SEWAGE DISPOSAL SYSTEM

MARYLAND STATE DEPARTMENT OF HEALTH

HOWARD COUNTY

A SEWAGE DISPOSAL SYSTEM LOCATED AT Dewall Rd - 1 mile from Mullinix Rd

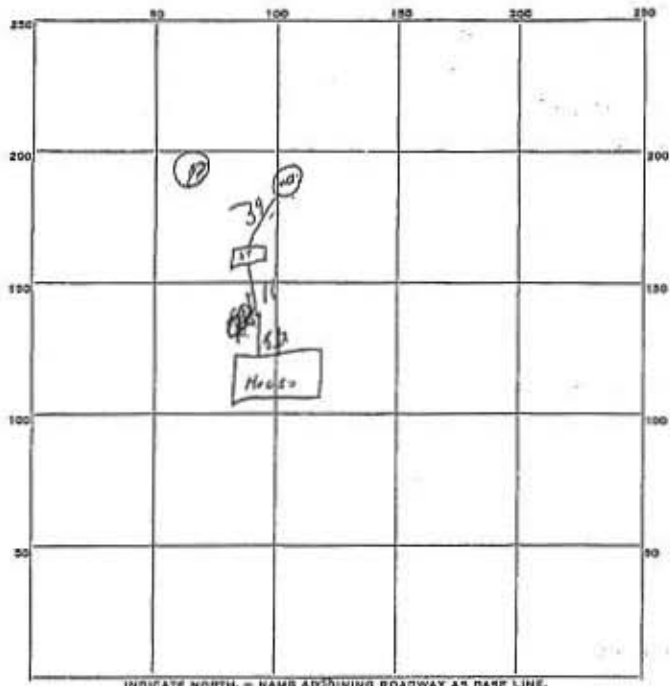
Place the dry well in the area that passed percolation which is about 121 feet behind middle of house

SEPTIC TANK, LEVEL ok CLEANOUTS OK

SEEPAGE PITS, INSIDE DIAMETER 10 FT. DEPTH BELOW INLET 7 1/4 FT.

ABSORBENT AREA 305 SQ. FT.
